# SERVICE BULLETIN

Service Bulletin No.: DAC1-32-01 Rev 0

Title: NLG Elastomer Pack Disk Retention

**Figure 1 – Detail of NLG Upper Disk Installation**

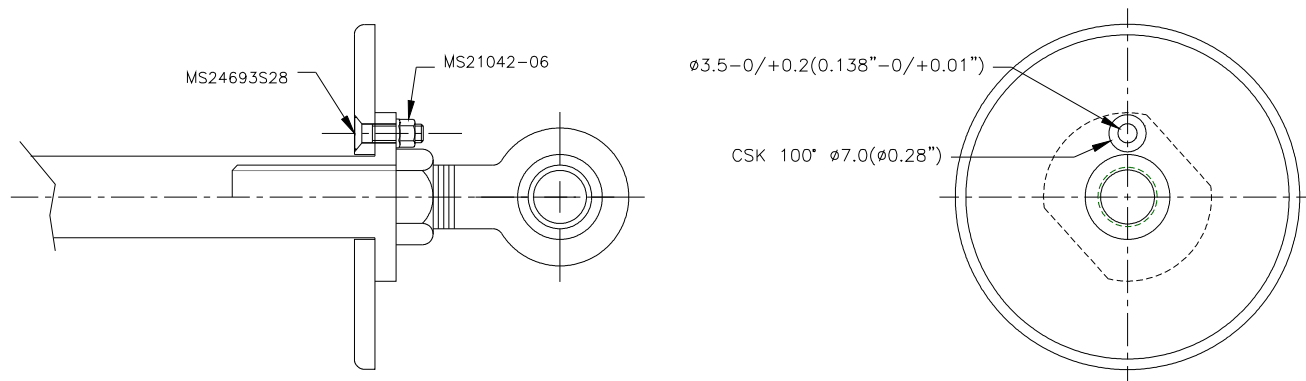
- 10.1 Remove nose landing gear elastomer in accordance with Maintenance Manual Chapter 32-20.
- 10.2 Remove and retain the adjusting nut, washer, bottom elastomer, journal, elastomer elements (x10) and spacers (x9).
- 10.3 Using a drift punch, carefully remove the spring pin that connects the upper disk to the shaft.
- 10.4 Carefully enlarge the hole in the disk and shaft to 0.138"-0.00"/+0.01") (3.5-0.0/+0.2mm).
- 10.5 Countersink the bottom side of the upper disk 100° to  $\Phi 0.28"$  (7mm) to accept the MS24693S28 screw.

- 10.6 Install the upper disk on the shaft with the MS24693S28 screw and MS21042-06 nut. Use Loctite on bare aluminum surfaces to prevent corrosion.
- 10.7 Assemble elastomer package in accordance with Maintenance Manual Chapter 32-20.
- 10.8 Install elastomer package in accordance with Maintenance Manual Chapter 32-20.
